International Aero Engines SERVICE BULLETIN

Subject: Transmittal of Revision 1 to Service Bulletin No. V2500-ENG-75-0052

ENGINE - AIR - INTRODUCE A VARIABLE
STATOR VANE ACTUATOR (VSVA) HAVING
A LINEAR VARIABLE DIFFERENTIAL TRANSDUCER
WITH EXTENDED TRAVEL

**ENGINE COMPRESSOR CONTROL - VARIABLE
STATOR VANE ACTUATOR - INTRODUCTION
OF NEW LVDT WITH INCREASED STROKE CAPABILITY INTO
VARIABLE STATOR VANE ACTUATOR JACK & REVISED
PISTON STOP.**

General view
Fig.1

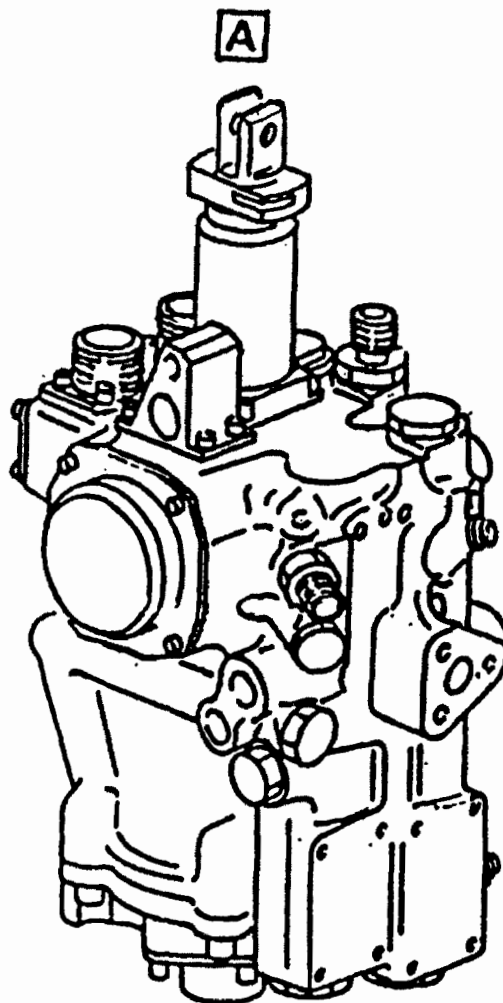
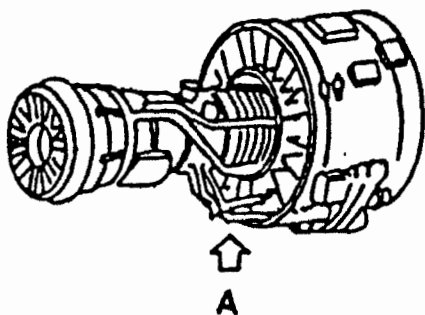
- (1) This Service Bulletin covers the fitment to engines of a Variable Stator Vane Actuator unit incorporating Lucas Modification DTV052.
- (2) This Service Bulletin introduces a new Linear Variable Differential Transformer with an increased stroke capability and a revised internal stop, to increase the ram travel of the Variable Stator Vane Actuator.
- (3) Units incorporating this Service Bulletin will be identified by the type number 2607MK1.

- (1) Install the new or reworked 2607 MK 1 Variable Stator Vane Actuator unit by use of approved procedures in References (2) and (3) Engine Manual, 75-32-41 Assembly.
